Business Class M2
Cascadia
108SD/114SD
> New Cascadia

**Freightliner
Service Bulletin**

General Information

Fig. 1, Location of the Rocker Panel and Chassis-Side Fairing

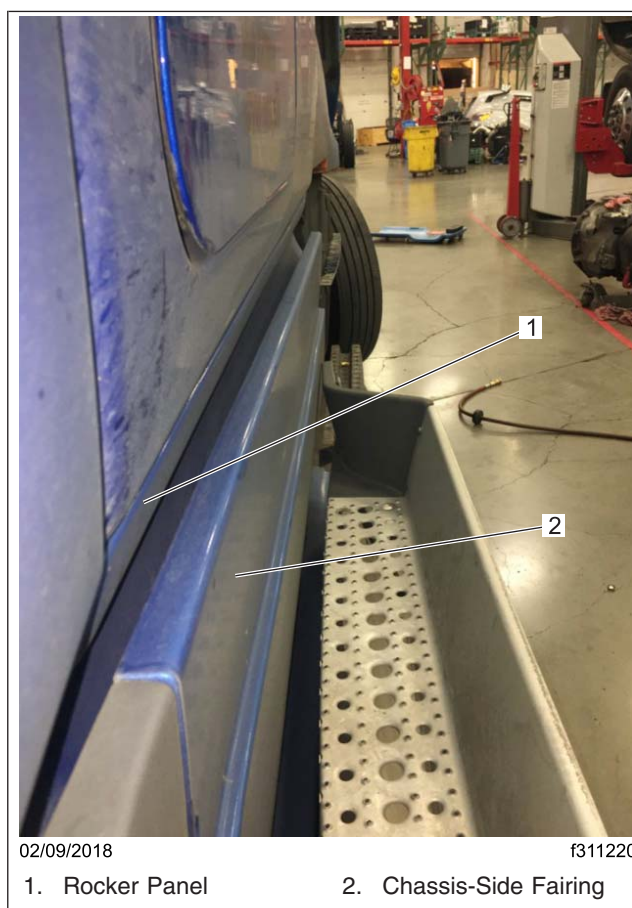
The right-hand cab rocker panel on New Cascadia vehicles can come into contact with the right-hand chassis-side fairing when making a left turn. This contact can result in an audible popping noise, paint damage to the rocker panel and damage to the back-side of the chassis-side fairing. See [Fig. 1](#). Beginning February 5, 2018, production added spacers between the track rod bracket and the rail. This will shift the aft of the cab to the left by 6 mm to provide clearance.

For vehicles built through February 4, 2018, follow the steps below to add shims and provide clearance. For vehicles built from February 5, 2018 with shims installed but still experiencing clearance issues, adjusting the fairing is all that is needed for clearance.

Fig. 2, Checking if the Inside Rib Contacts the Chassis-Side Fairing (fuel tank mounting shown)

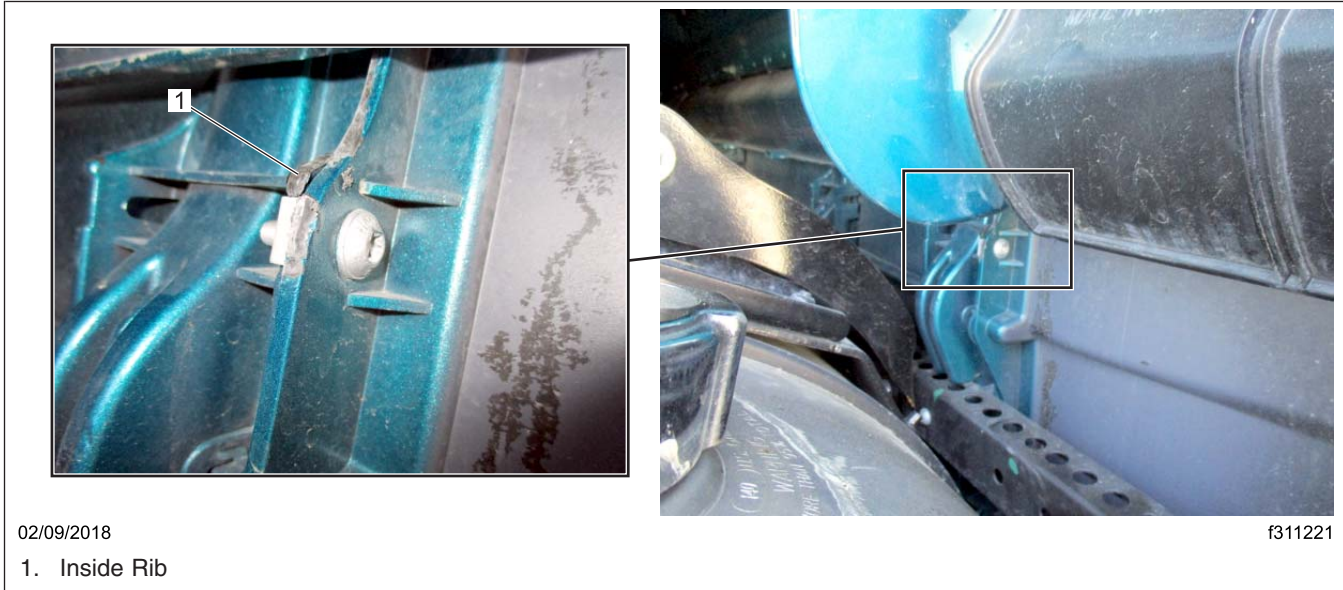
1. To determine if this problem exists, check for an indication of contact on the inside rib on the chassis-side fairing. See [Fig. 2](#).

Fig. 3, Installing the Shim

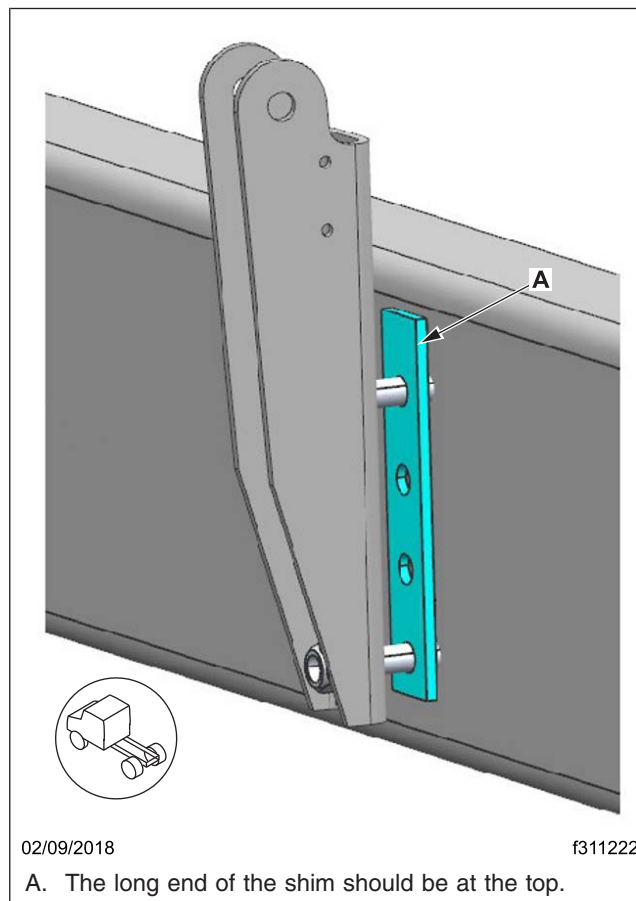
2. If there is contact on the inside rib on the chassis-side fairing and the vehicle was built before February 5, 2018, install a shim between the frame rail and the lateral control rod frame bracket to resolve this interference. Tighten the hex bolts 128 lbf·ft (174 N·m). See [Fig. 3](#).

Fig. 4, Adjusting Frame Mounted Fairings

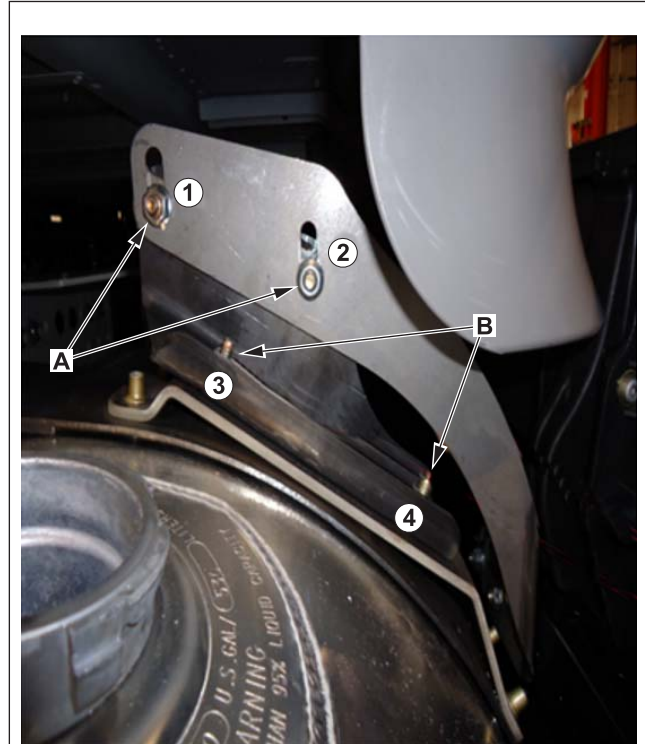
3. Ensure that the frame fairing mounting bracket is adjusted down and outboard to clear the rocker panel. Spacers on the fairing are not needed; adjusting alone should fix the issue. See [Fig. 4](#).

Fig. 5, Adjusting Fuel Tank Mounted Fairings

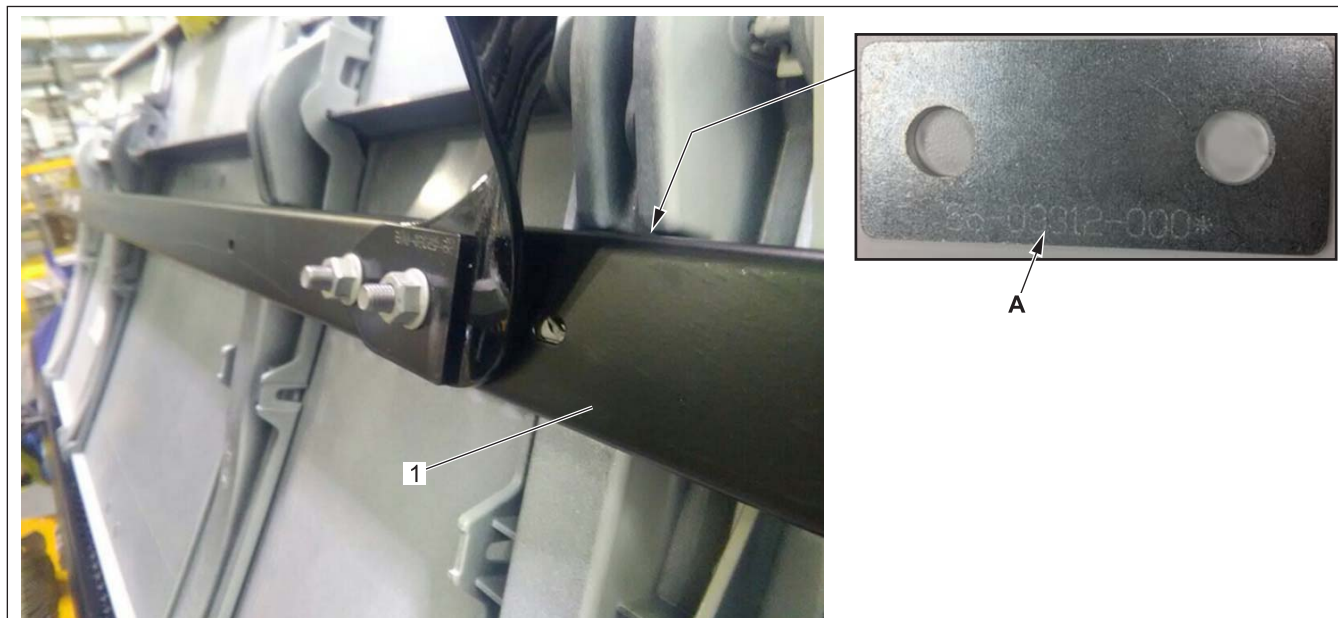
1. To determine if this problem exists, check for an indication of contact on the inside rib on the chassis-side fairing. See [Fig. 2](#).
2. If there is contact on the inside rib on the chassis-side fairing and the vehicle was built before February 5, 2018, install a shim between the frame rail and the lateral control rod frame bracket to resolve this interference. Tighten the hex bolts 128 lbf·ft (174 N·m). See [Fig. 3](#).
3. Ensure that the fuel tank fairing mounting bracket is adjusted as far down and outboard as possible to clear the rocker panel. See [Fig. 5](#).
